**Report of the Chief Planning Officer**

**PLANS PANEL EAST**

**Subject: The report refers to the following applications proposing various alterations and externally illuminated signage to the Old Star Inn, Leeds Road, Collingham, Wetherby LS22 5AP**

Client:  
Project:  
**THE OLD STAR P.H.**  
**COLLINGHAM, LS22 5AP**  
Drawing Title:  
**PROPOSED SITE PLAN**

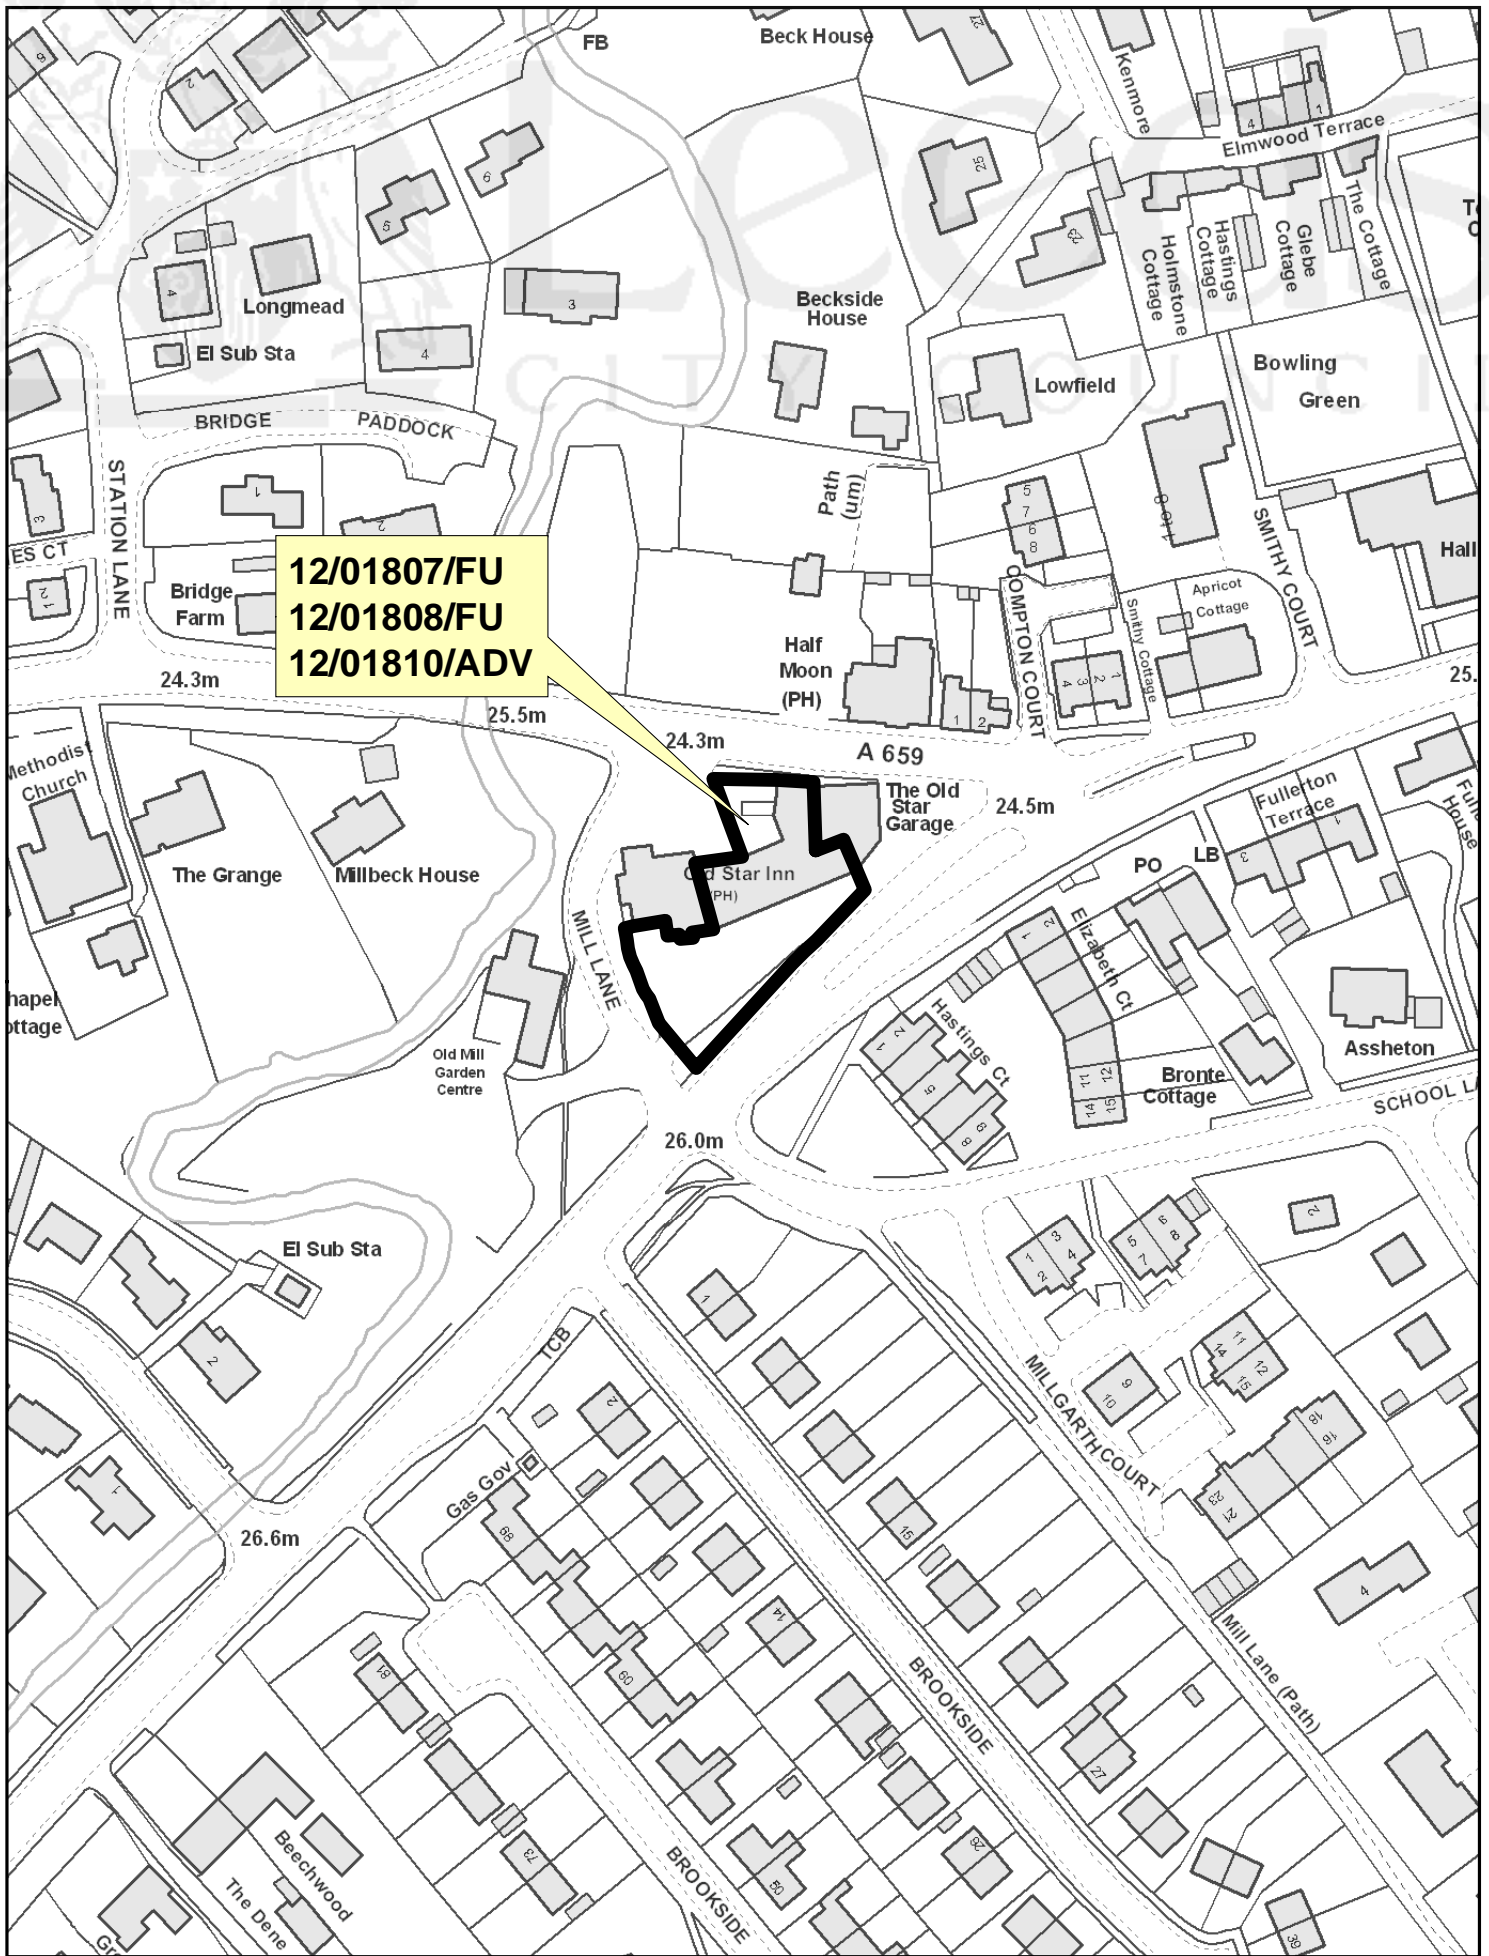
7.2 The **Highways Officer** originally commented that the overall external boundary of the site (red/blue line combined) stops short of the adopted part of Mill Lane, thus leaving a gap between the service yard and the means of access to the external highway network, it also suggested that the line of the front boundary is incorrect and that the proposed front wall may be positioned on highways land.

7.7 Concerns were raised by the Conservation Officer with regards to the fence proposed to enclose the plant units to the rear. The plans have been revised to now show a stone wall to enclose the proposed plant.

- 10.33 The concerns raised that the timber-screening fence will appear out of character with the Conservation Area, is a valid point. The applicant has revised the drawings to replace the fence with a stone wall.

7.3 The applicant has submitted a revised site plan to correct the blue line boundary and to show the wall positioned within the site boundary.

- C. 06.07.12 Fence to service yard amended to coursed stone wall MED
- B. 03.07.12 "Publicly maintained highways" plan undertaken. Parking amended as a direct result of proposed wall needing to be moved back from the previously understood boundary MED
- A. 20.03.12 Timber fence to service yard shown MED
